Plan Change 7 to the Canterbury Land and Water Regional Plan

Responses to Questions of Hearing Commissioners on Council s42A Report dated 28 May 2020, and additional questions dated 16 June 2020

Attachment 1: Map of the Groundwater Provinces in the OTOP sub-region

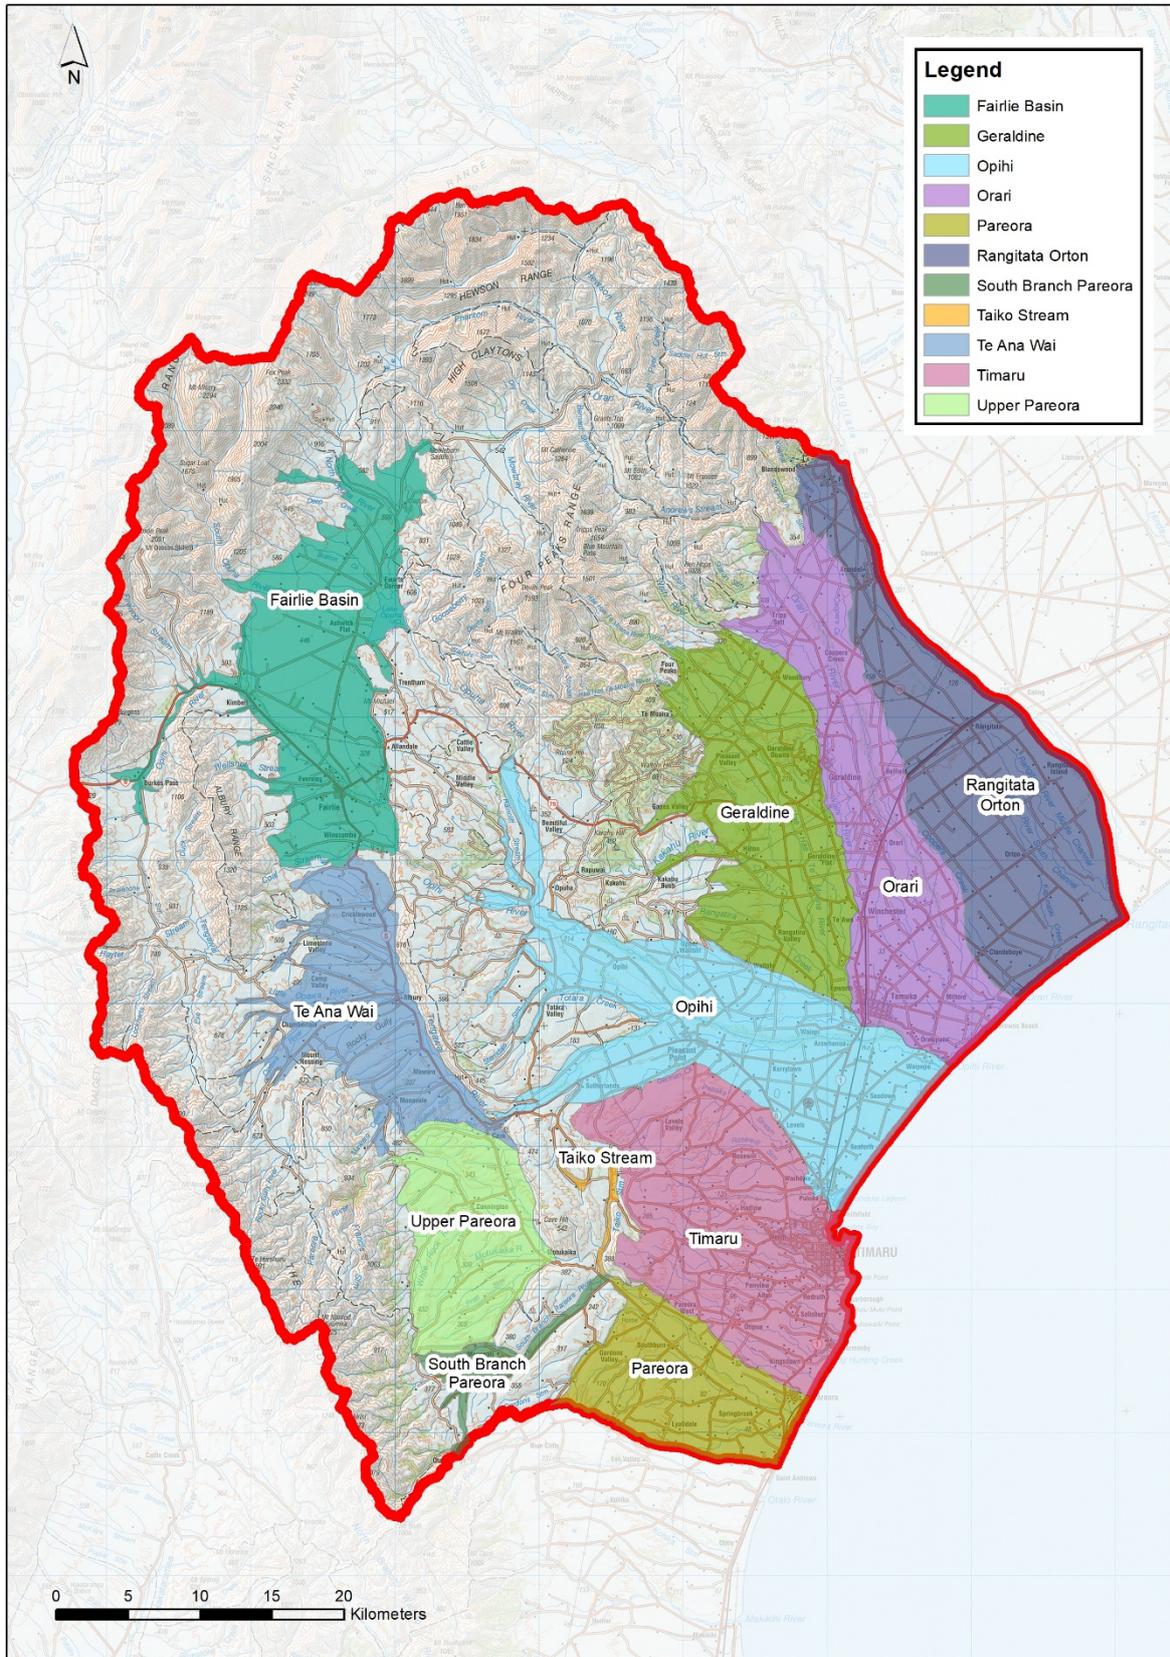
246	3.60	<p>Table 14(g) – How is a ‘groundwater province’ different from a ‘groundwater allocation zone’? Is this concept described in any supporting documents?</p> <p><i>Response – MMC</i></p> <p>In PC7, groundwater provinces are used to describe areas where groundwater is managed for quality purposes, whereas groundwater allocation zones are used for quantity management. Practically, there is little difference. However, as the areas are managed for different purposes, and do not necessarily cover the same geographic area (for some, more than one province is in a groundwater allocation zone), they are named differently.</p> <p>The explanation of Table 14(g) on page 187 of the Section 32 Report states: <i>Table 14(g) delineates separate groundwater provinces within the OTOZ sub-region as sub-units within the FMU.</i> There is a map of the groundwater provinces in the OTOZ Zone Implementation Programme Addendum (ZIPA) – it is attached to these answers as Attachment 1.</p>
